# TECHNICAL SERVICE BULLETIN

DATE: 9/8/69

Stop Light Switches

Spitfire MK III, GT-6+

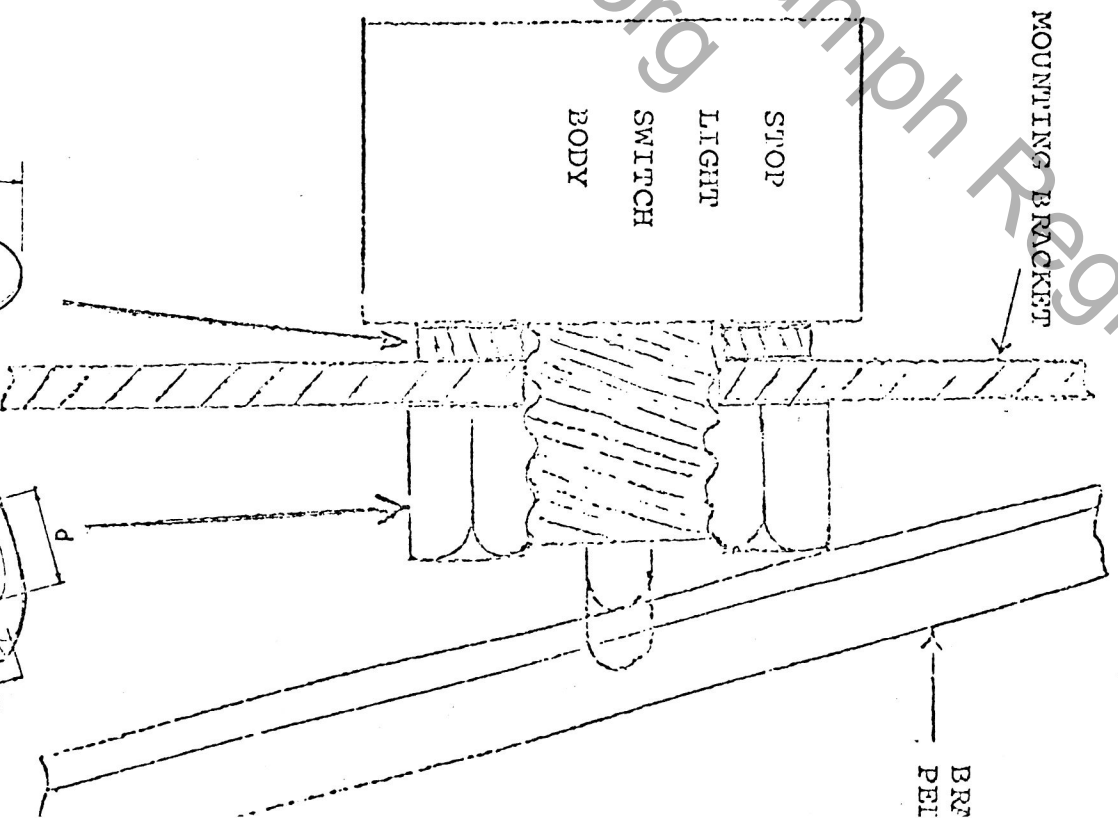
A modification is now in effect in order to prevent premature failure of the stop light switches, Part #134529, due to the switch being physically damaged by the brake pedal lever.

The modification consists of removing the switch assembly from its mounting bracket. Discard the fixing nut, Part #JN 2111, and plain washer, Part #WM 0711. Refit the switch to its mounting bracket but first place a new plain washer over the threaded portion of the switch between the mounting bracket and the switch body, as shown in the attached sketch. Fit a new nut, this has the effect of increasing the clearance between the switch plunger and the brake pedal. The thicker nut will also act as a pedal stop. Retroactive action is not considered necessary.

OLD CONDITION

NEW CONDITION

Washer Dimensions:-  
B = 1"  
d = 1/2"

Nut Dimensions:-  
A = 3/4" A  
d = 1/2" UNF
